## ADDENDUM NO. 1

**Erosion Control, Paving Repairs, and Renovations  
Troop I Headquarters  
Rolla, Missouri  
Project No. R2405-01**

TROOP I HEADQUARTERS & CDL  
EROSION CONTROL & PAVING  
REPAIRS & GARAGE BUILDING  
RENOVATION

PROJECT # R2405-01  
SITE # 6010  
FACILITY # 8136010004  
8136010005

**E-100**

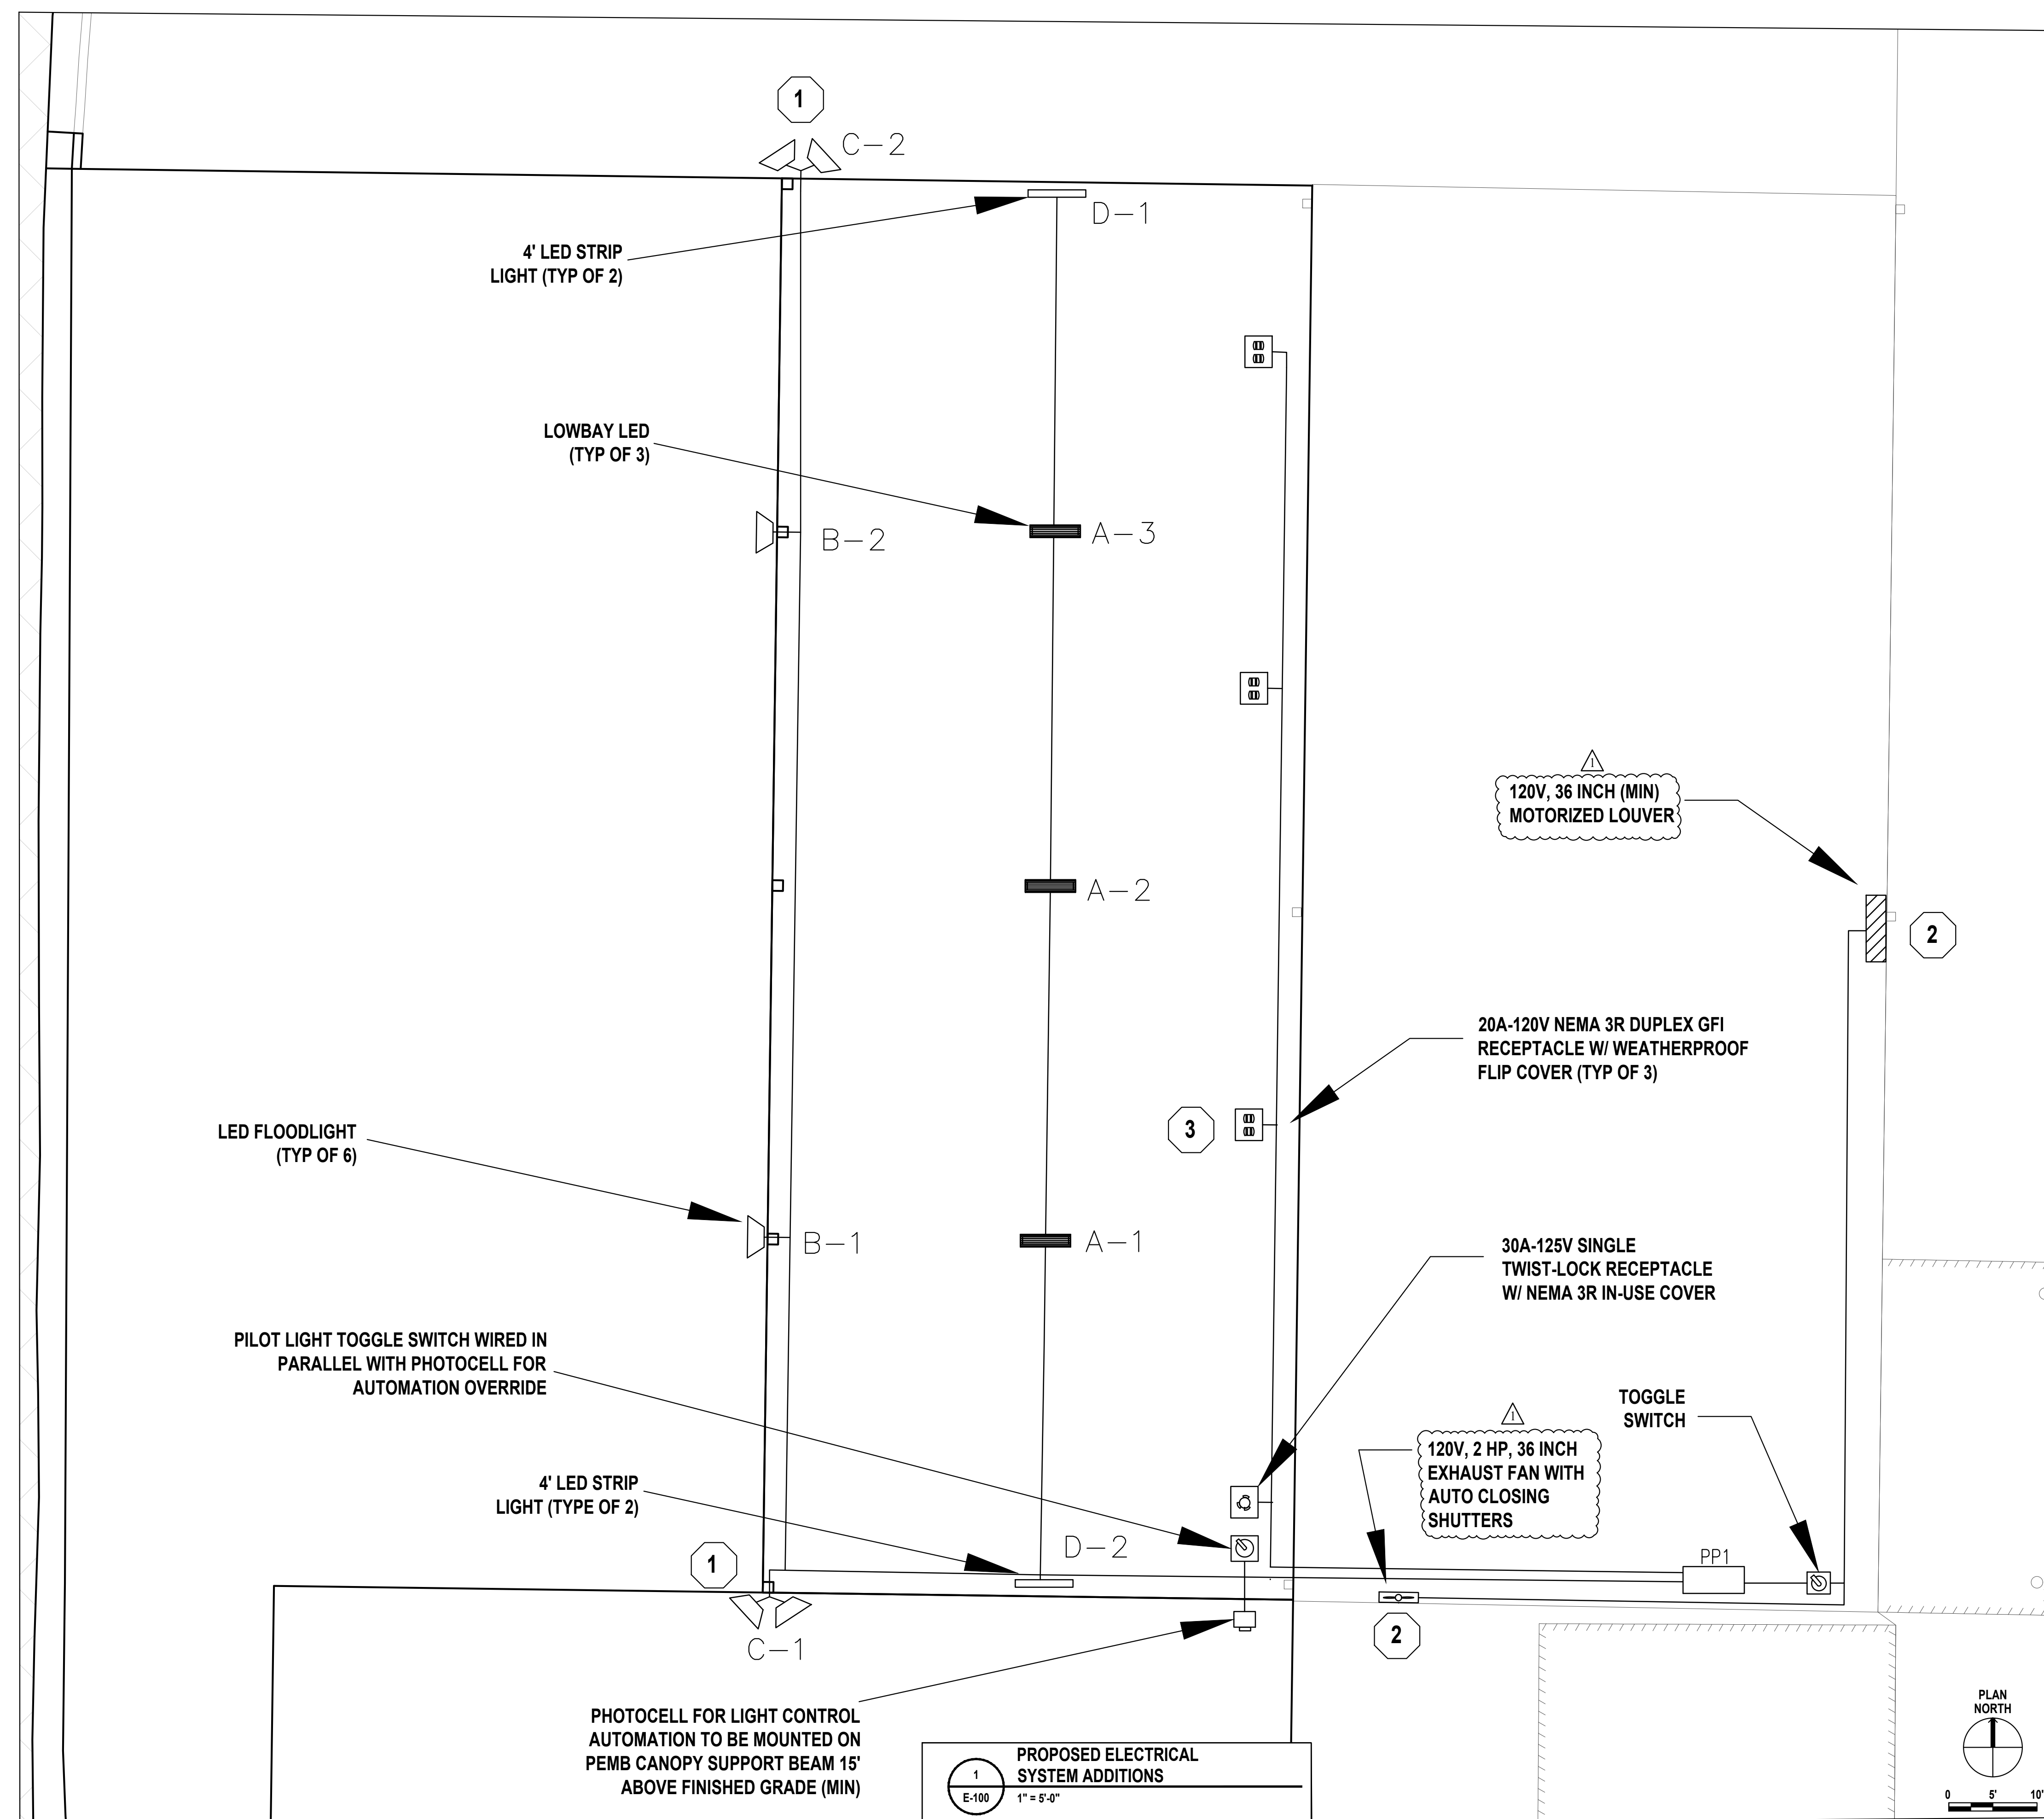
1. Sheet C-300
  - a. ADD – The gas meter shall be relocated to the northwest corner of the existing garage building. Coordination will need to be made with Ameren Gas.
2. Sheet C-501
  - a. Remove JOINT LAYOUT DETAIL. Refer to 1/S-100 for the control joint layout.
3. Sheet A-801
  - a. REMOVE from 07420 – METAL ROOFING Specification: Requirement for ¾” plywood under metal panels.
4. Sheet E-100
  - a. Louver shall be 120V, 36-inch (min.) and motorized.
  - b. Exhaust fan shall be 120V, 2 HP, 36-inch with auto closing shutters.
5. Sheet E-101
  - a. REVISE exhaust fan motor to show 2 HP.
